1. Solicitation No. CSP 23-005 New Braunfels Fire Training Complex Site Infrastructure	2. Contract No.	3a. Addendum No. 1 3b. Modification No.	4. Effective Date of this Action 12/16/22
5. Name and Address of Offeror or Contractor	6. For Information Call: (No collect calls or Fax offers accepted) Purchasing: Barbara Coleman Phone No.: 830-221-4389 Fax No.: 830-608-2112		7. Amount of Contract/Order is: Increased by: Decreased by: New Total: <input type="checkbox"/> Unchanged

This Addendum No. 1 provides the minutes to the Pre-proposal Conference hosted on December 7, 2022 and answers to questions received by the question deadline of December 9, 2022.

ADDENDUM NO. 01

PROJECT: NEW BRAUNFELS FIRE TRAINING SITE INFRASTRUCTURE
LOCATION: NEW BRAUNFELS, TEXAS
PROJECT NO: 219065.00
DATE: DECEMBER 14, 2022

UTILITY PLAN

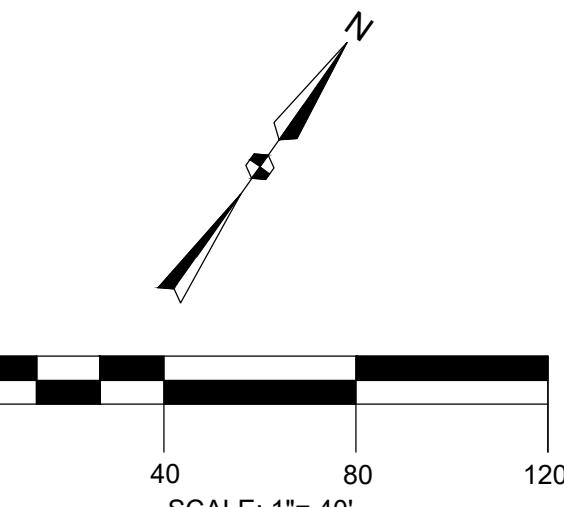
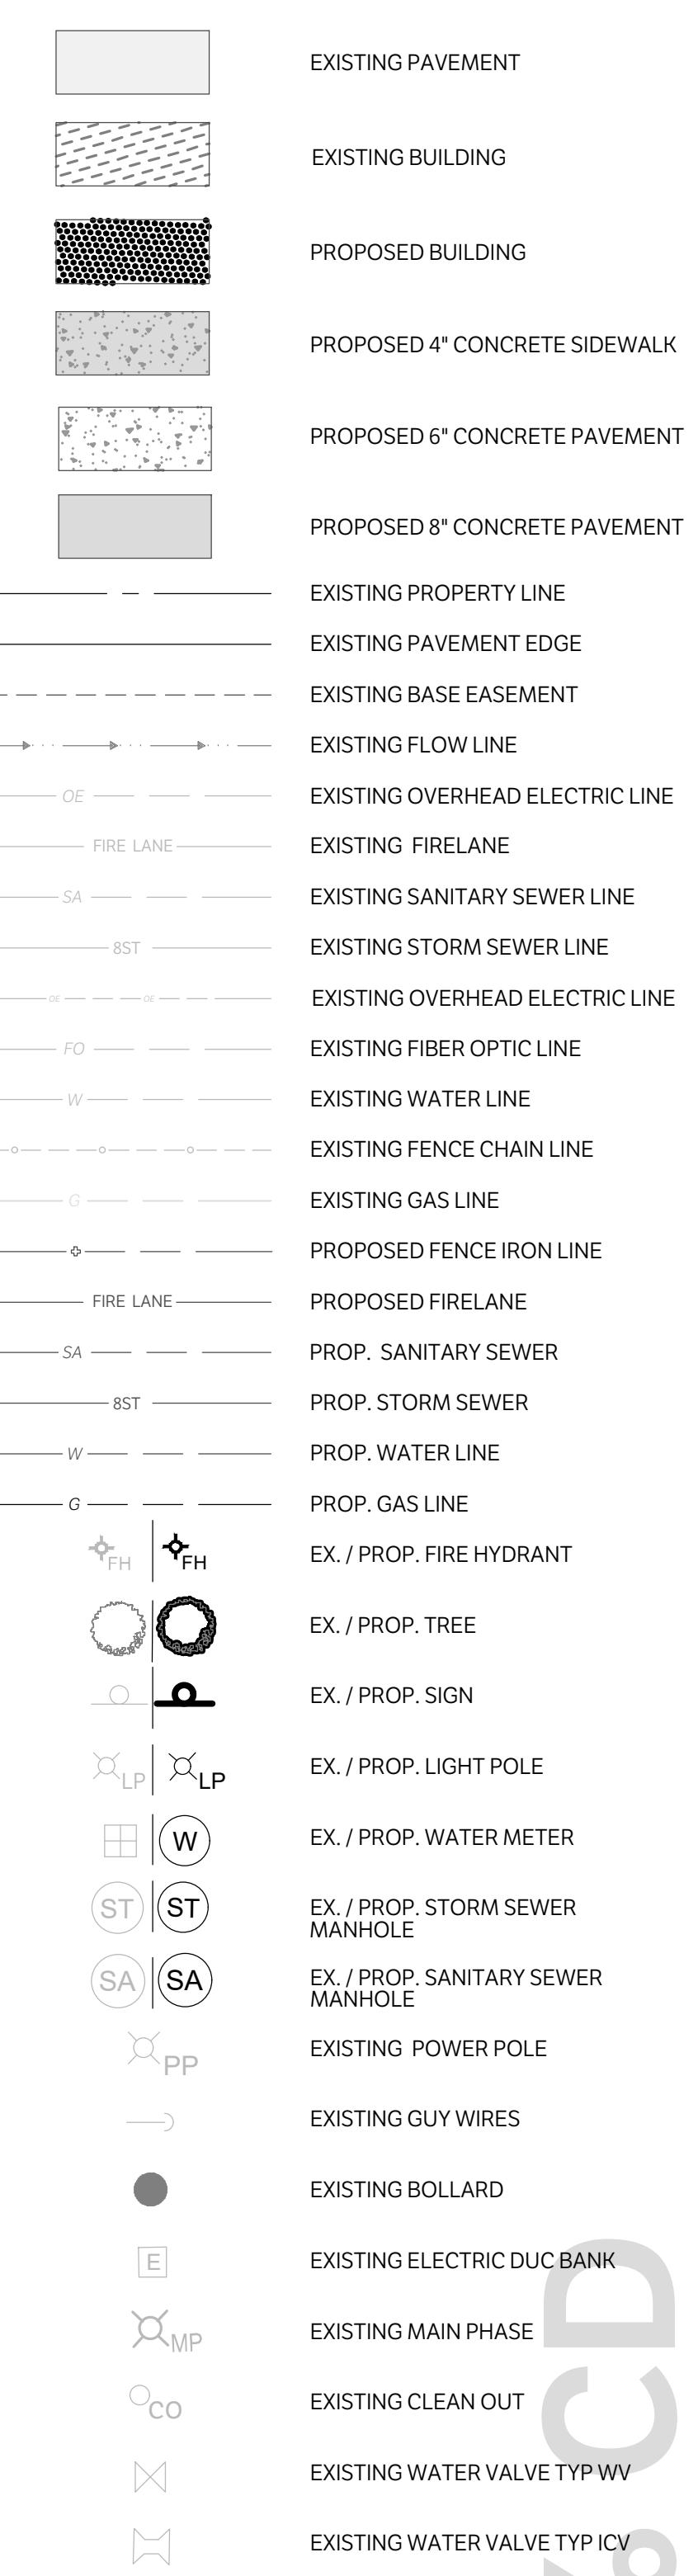
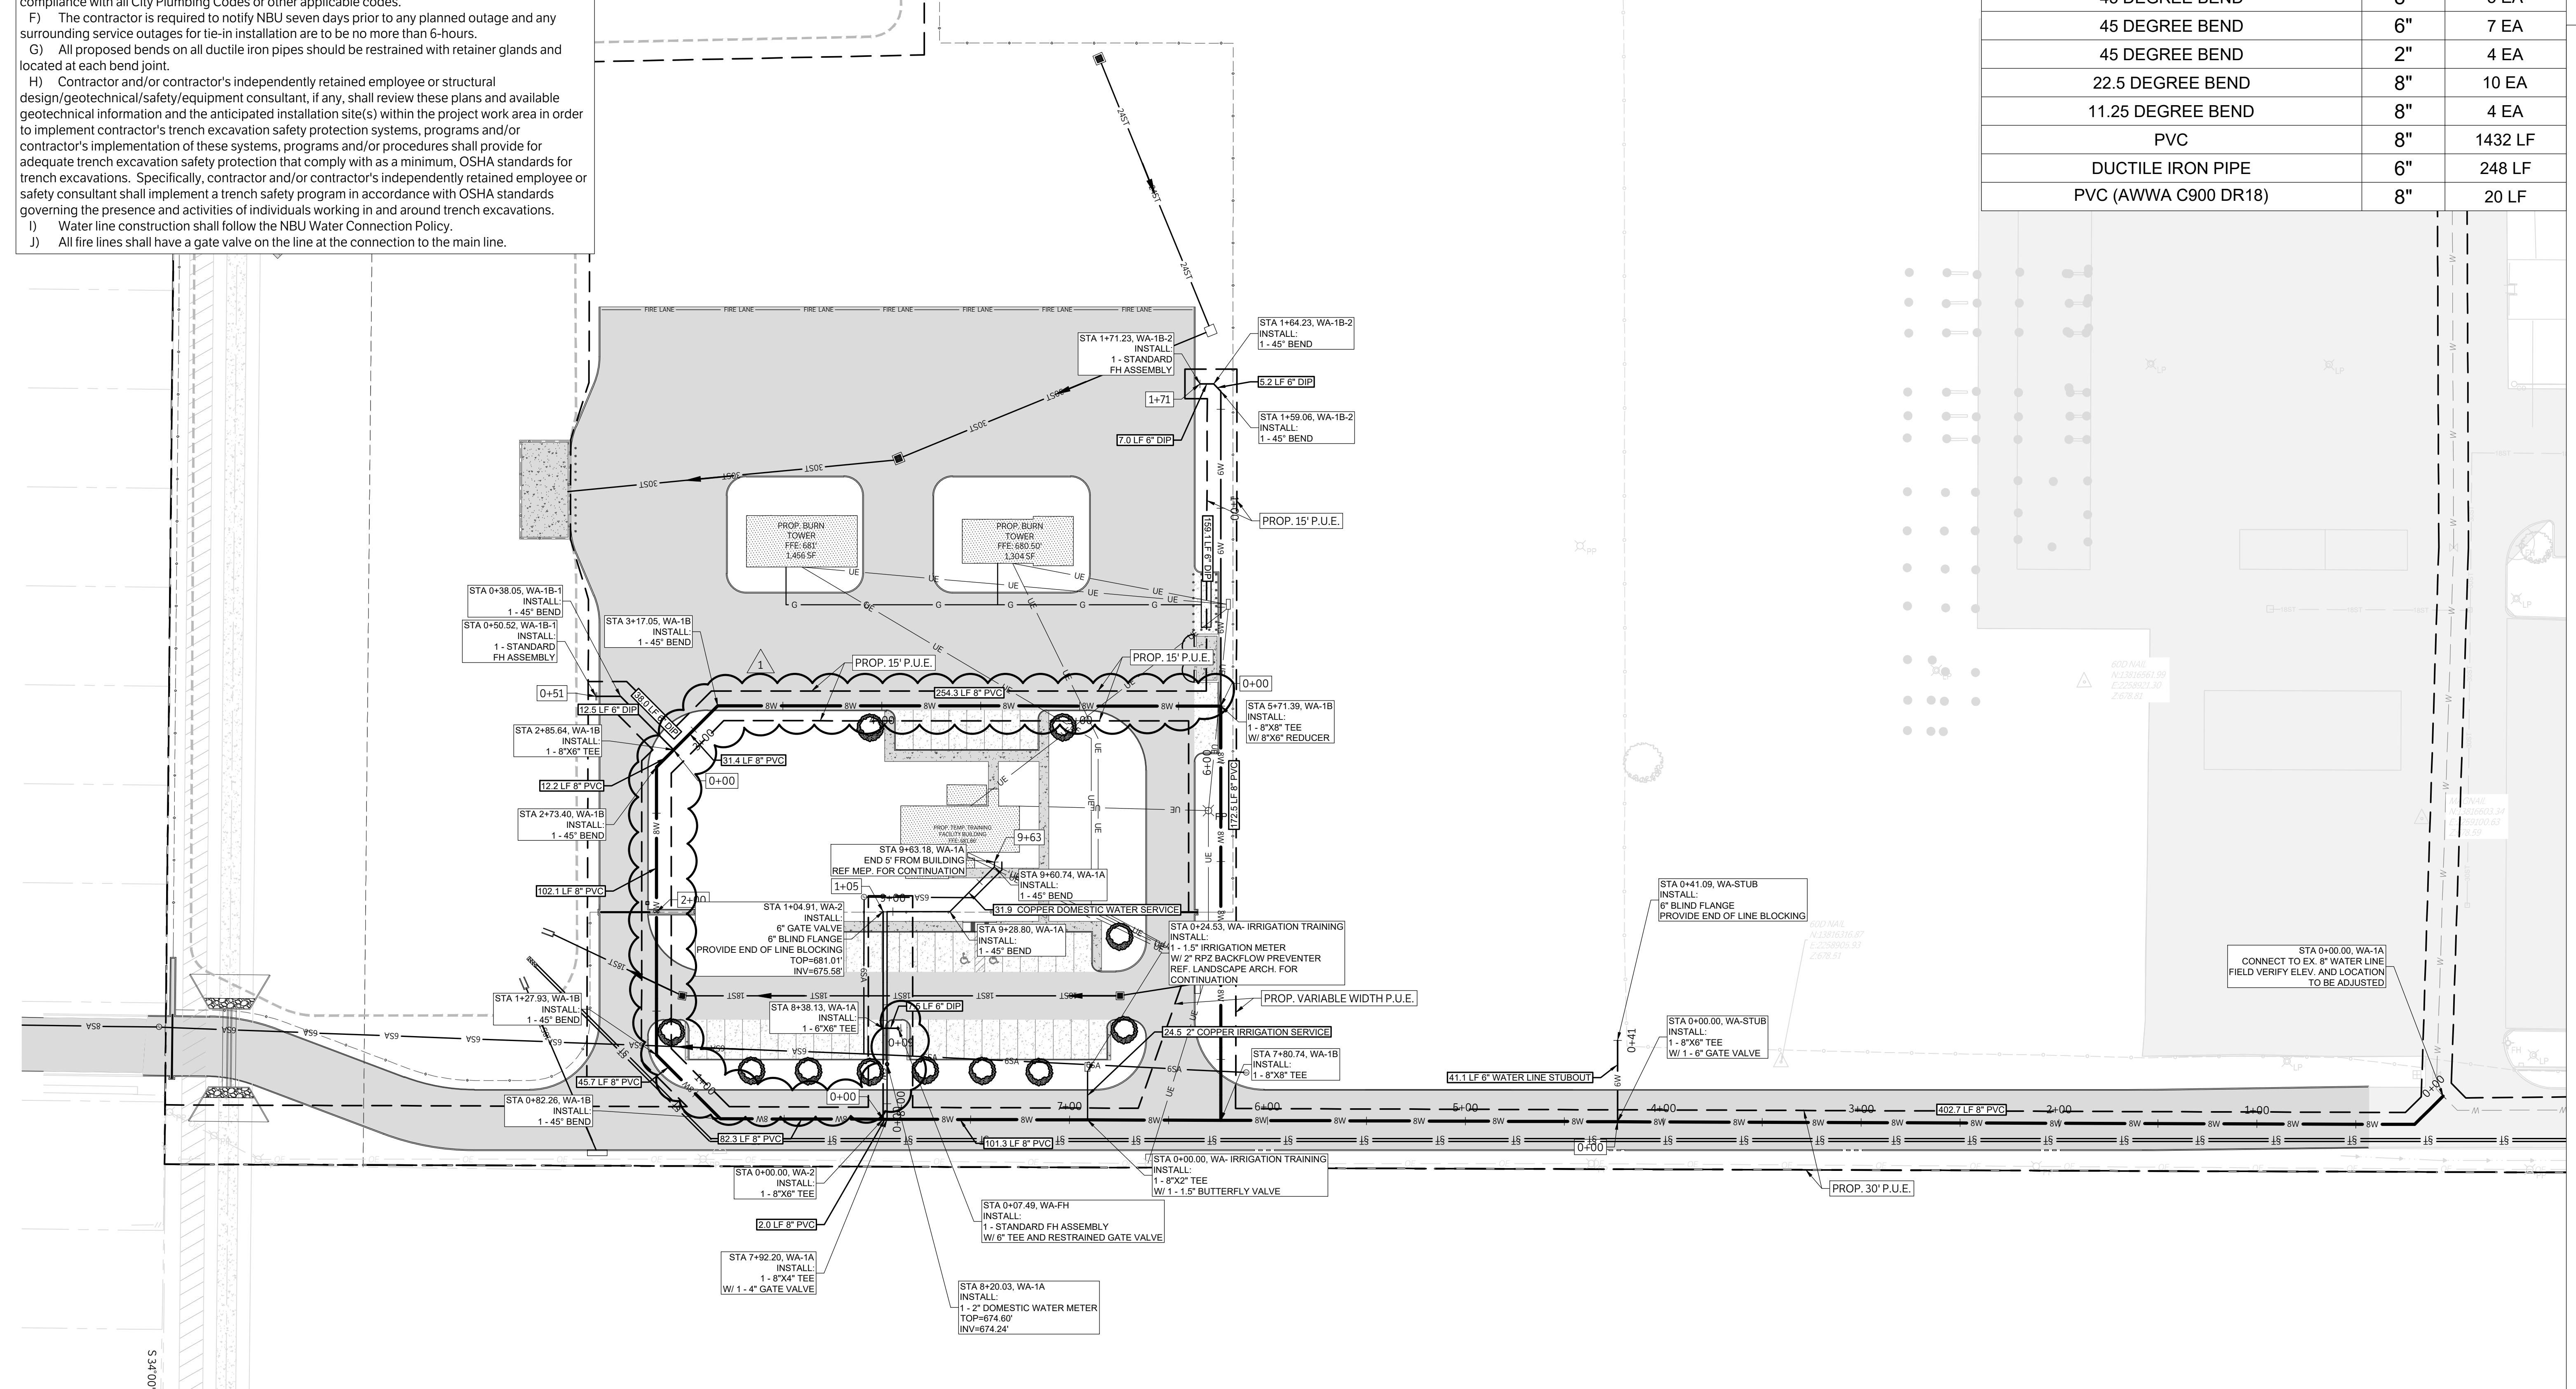
Item No. 3 (RE: Sheet C4.0) – Utility Plan
A. The water line loop around the training facility was expanded to accommodate the future training facility.
B. One of the 8"x6" tee connections to the 8" loop was removed and relocated to branch off of the 6" fire water line stub out running to the building instead.
C. The easement was also adjusted to follow the new routing of the water line.
D. The irrigation meter was reduced to a 1.5" meter, and callouts for valves were added to the water lines for clarity.

IRRIGATION PLAN AND DETAILS

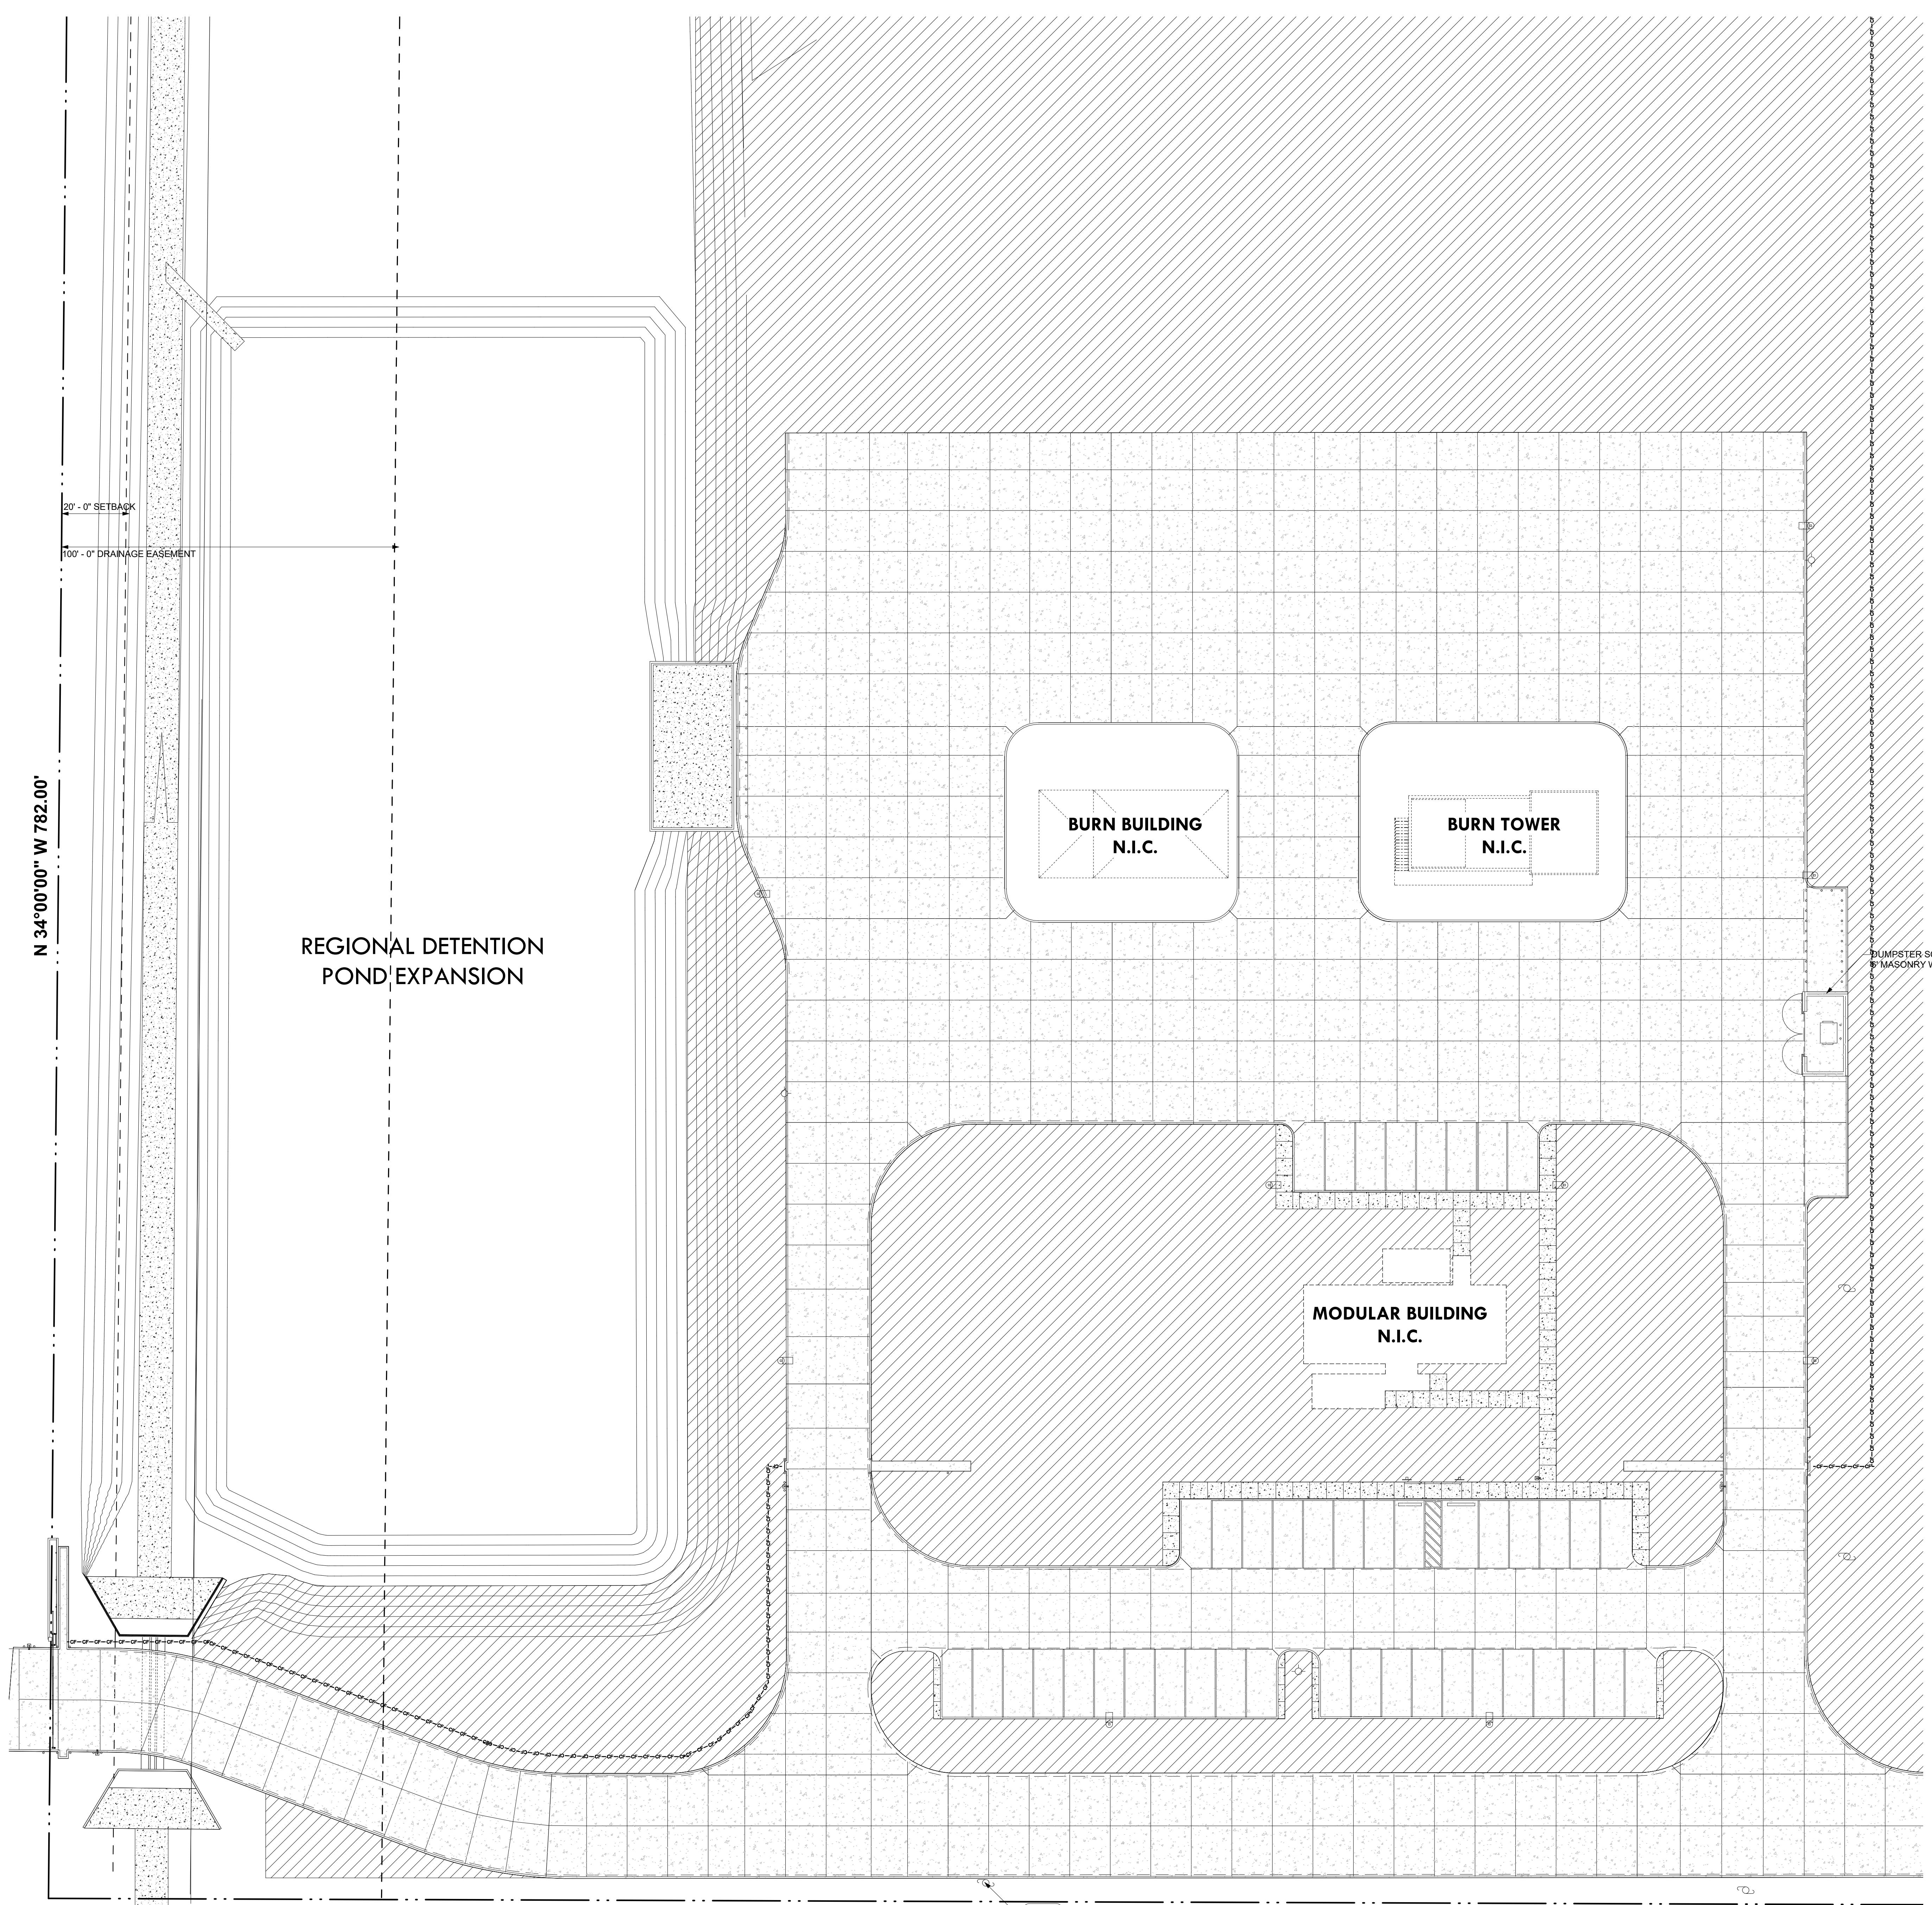
Item No. 6 (RE: Sheet L1.3, Legend) – Irrigation Plan and Details

B. The Irrigation Manufacturer has been changed to state “Manufacturer must be acceptable per the New Braunfels Parks Specifications” see attached.
